# Summary of Preliminary Findings: CORMIX Modeling of City of Sandpoint Discharge

Prepared by Brian Nickel, EPA Region 10

**Figure 2: Dilution isoline for a 9% acute mixing zone (29:1) at the 4B3 flow rate.**

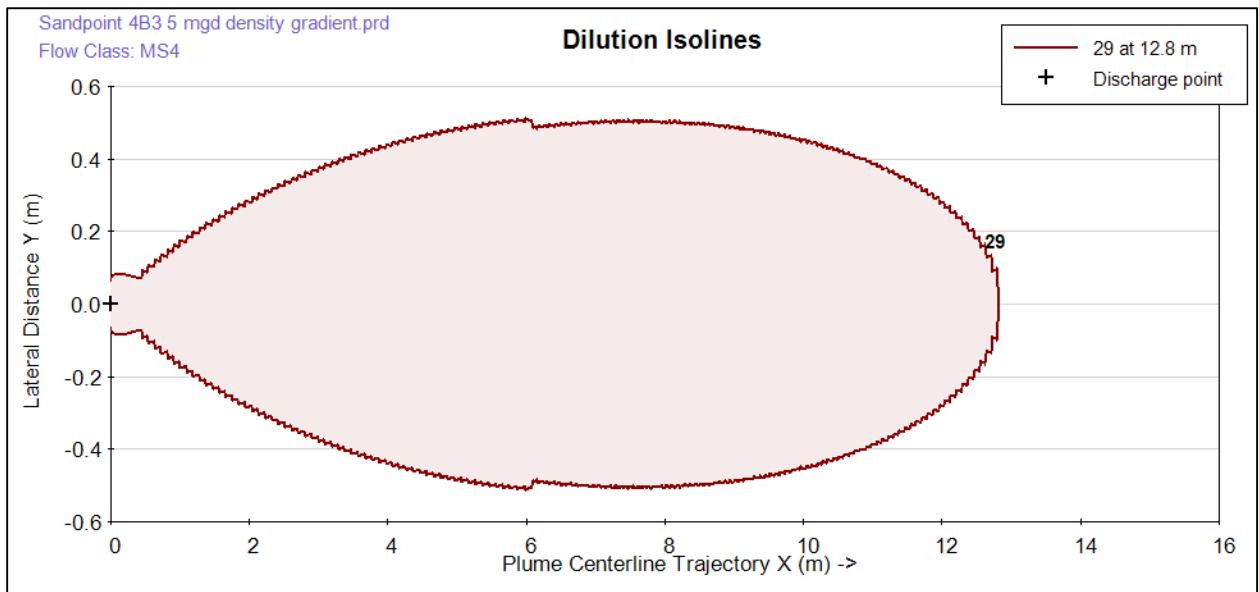
- Limiting the acute mixing zone to less than 15 minutes (900 seconds or 0.25 hours) of plume travel time, as recommended in the *Technical Support Document for Water Quality-based Toxics Control* for low-velocity discharges, results in an acute dilution factor of about 30:1, or a mixing zone of about 9-10% of the 1Q10 stream flow (see Figure 2). Compare this to an acute mixing zone of 25% of the 1Q10, which provides a dilution factor of 79:1.

**Figure 3: Dilution isolines for 20% (210:1), 15% (158:1), and 10% (106:1) mixing zones at the 30B3 flow rate.**

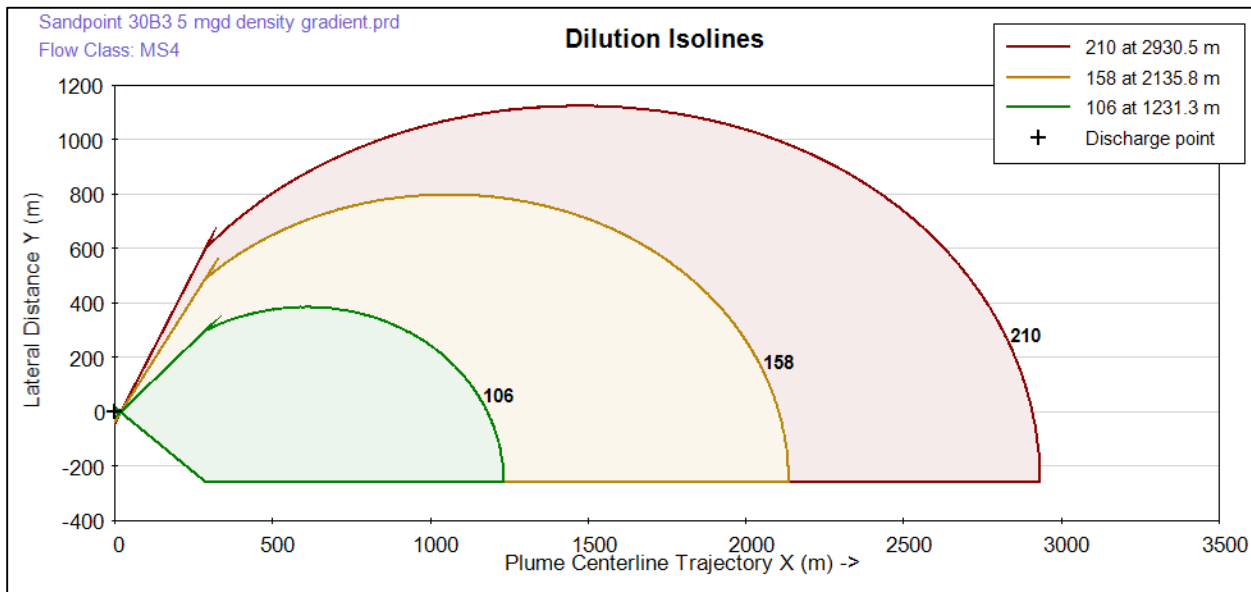
- Ensuring that the mixing zones for chronic ammonia (30B3 flow rate) and for human health criteria for non-carcinogens (e.g., arsenic, 30Q5 flow rate) and carcinogens (harmonic mean flow rate) does not extend to the Albeni Falls Dam (27 miles or 43 km downstream) requires a mixing zone smaller than 25% of the stream flow. A mixing zone of 20% of the appropriate critical flows would avoid this outcome (see Figures [3](#), [4](#) and [52](#)).

- Ensuring that the mixing zone for chronic ammonia (30B3 flow rate) does not exceed 25% of the width of the river requires a mixing zone no larger than about 15% of the stream flow (see Figure 3). The river is 9600 ft wide at the point of discharge; 25% of this is 2,400 feet or 732 meters.

**Figure 4: Dilution isolines for 20% (191:1), 15% (144:1), and 10% (96:1) mixing zones at the 30Q5 flow rate.**

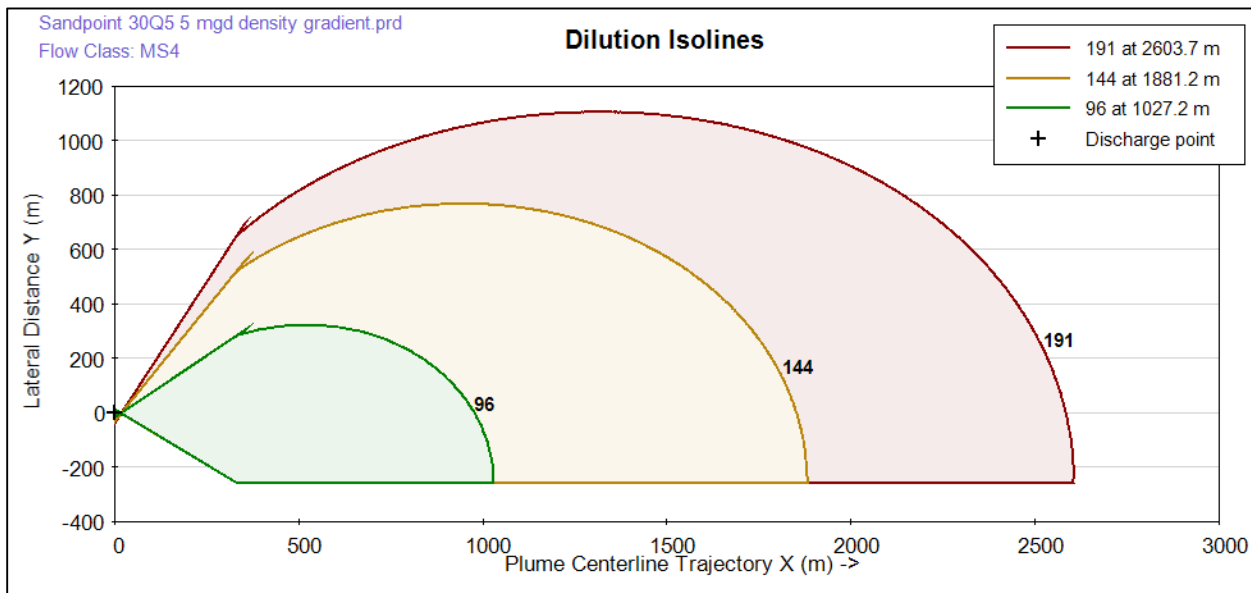
- Ensuring that the mixing zone for human health criteria for non-carcinogens (3Q5 flow rate) does not exceed 25% of the width of the river requires a mixing zone no larger than about 15% of the stream flow (see Figure 4).
